SUBJECT: CERTIFICATION OF THE MINUTES FOR THE U.S. EPR
SUBCOMMITTEE MEETING ON MAY 8, 2013, ROCKVILLE,
MARYLAND

ADVISORY COMMITTEE ON REACTOR SAFEGUARDS
MINUTES OF THE ACRS US-EPR SUBCOMMITTEE MEETING
MAY 8, 2013

The purpose of the meeting was to hear presentations and discuss the information contained in Chapter 2, "*Site Characteristics*," Section 2.5, and Chapter 13, "*Conduct of Operations*," of the Safety Evaluation Report (SER) with Open Items related to the review of the Calvert Cliffs Unit 3 Combined Operating License Application (COLA) FSAR, which references the U.S. EPR DCD.

➤ Settlement

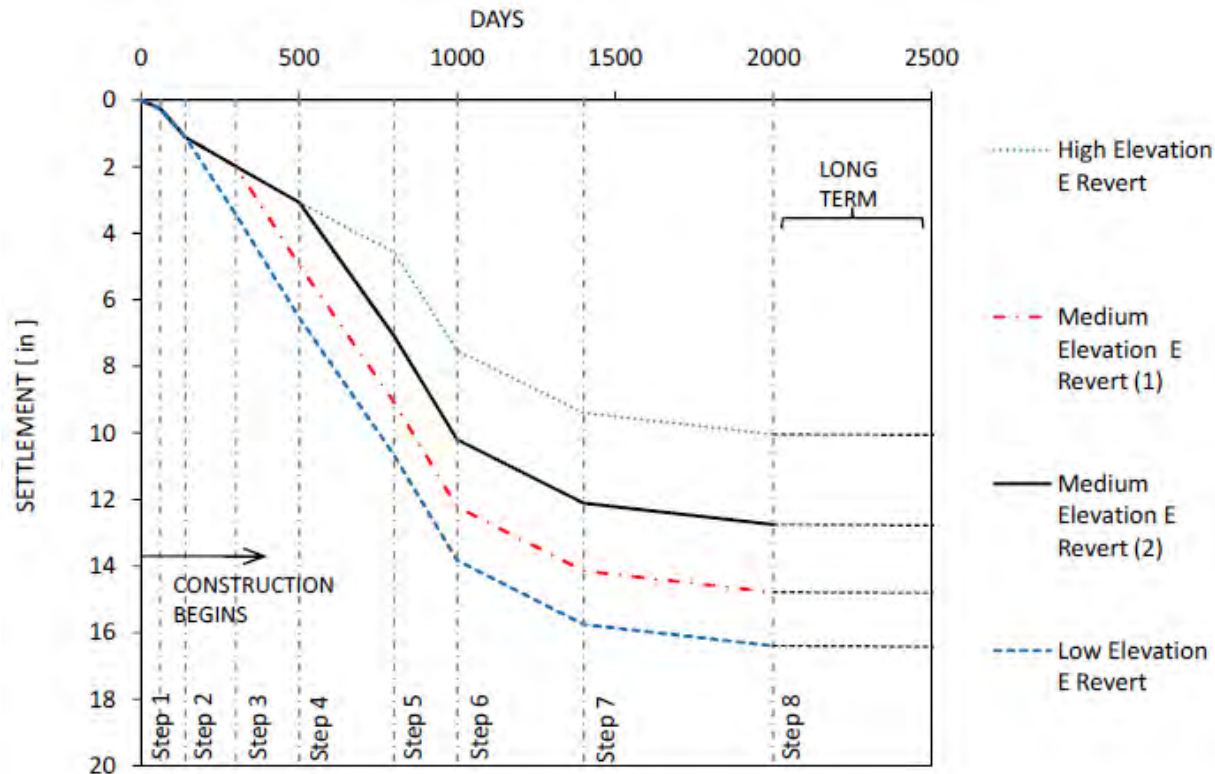
7 MEMBER SKILLMAN: What is the real risk to
8 the plant if your settlement predictions are not
9 fulfilled? It seems to me that between buildings, where
10 there's a settlement that you did not anticipate, the
11 risk would be structures, pipes, connections, conduits,
12 cabling that is tensioned or twisted or bent beyond what
13 you anticipate in your basic engineering design.

14 So my question is, for the uncertainty in
15 settlement between buildings and this departure, is
16 there an engineering remedy that you have applied?

17 MR. FERNANDEZ: That's a very good
18 question. And right now it's also being tracked through
19 an ITAAC that we have from the staff. WE have an RAI
20 to incorporate an ITAAC on settlement that deals with
21 that question. What is the description of your
22 settlement monitoring program and what actions are you
23 taking to deal with those types of risks in case your
24 settlement estimate exceeds your expectations?

PSHA Evaluation

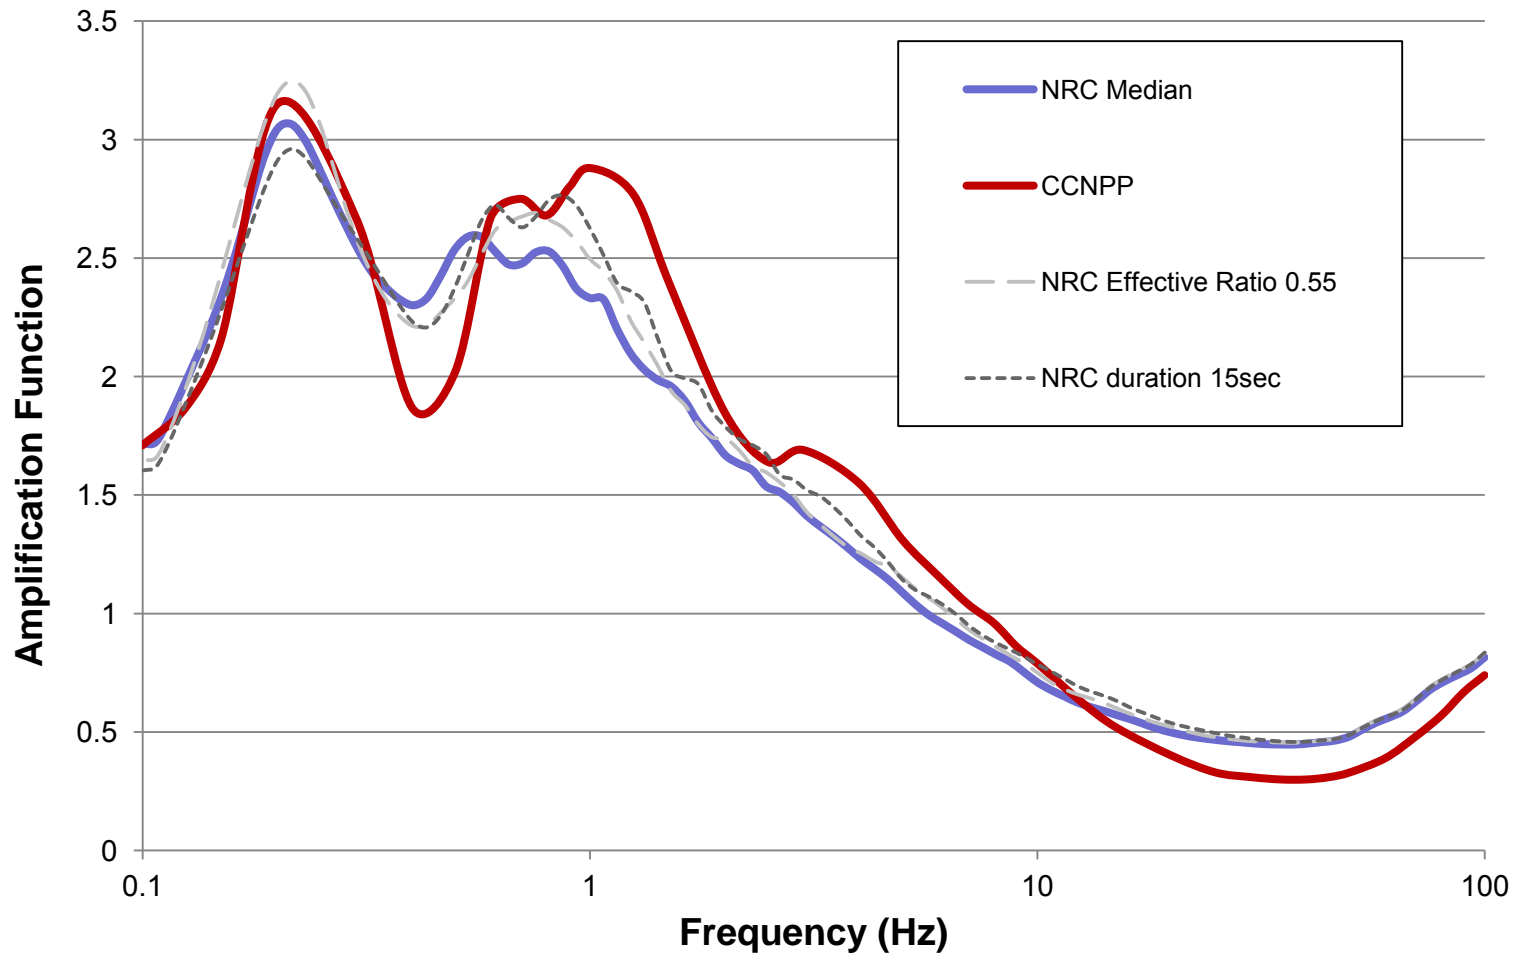
- ❖ In RAI 385, Question 02.05.02-26, the staff requested further information on the sensitivity study conducted to analyze the impact of the Mineral, VA earthquake on the seismicity rate increases. The staff received the study details on April 22, 2013, but has not been able to review and confirm the full impacts of the Mineral, VA earthquake on CCNPP Unit 3 PSHA results. This issue is being tracked as an open item.

- ❖ **Open Item 02.05.02-2 – Confirmation of full PSHA results:**
 - ◆ In RAI 381, Question 2.5.2-25 the staff requested hazard contributions of individual seismic sources to conduct an independent confirmatory study. The staff has not finalized its confirmatory study and the issue is being tracked as an open item.

❖ Departure #2:

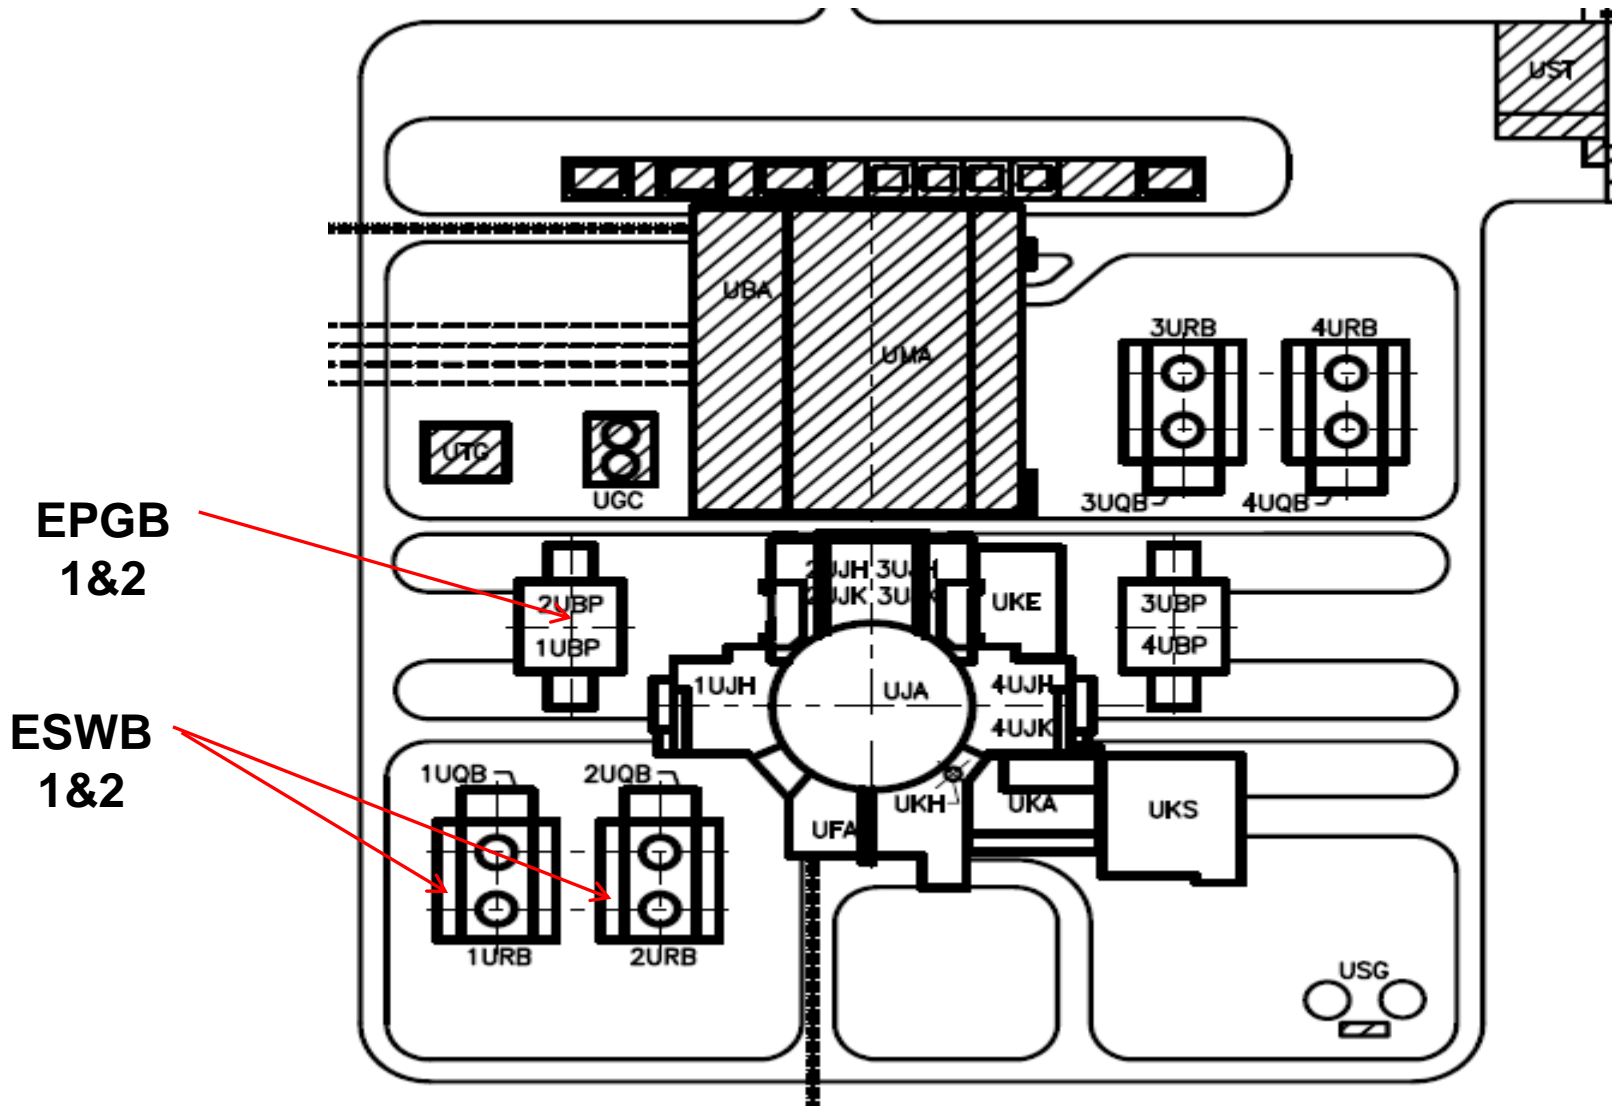
- ◆ The estimated tilt settlements for ESWB 1&2 and EPGB 1 do not meet the U.S. EPR FSAR requirement of $\frac{1}{2}$ inch per 50 ft (or 1/1200)
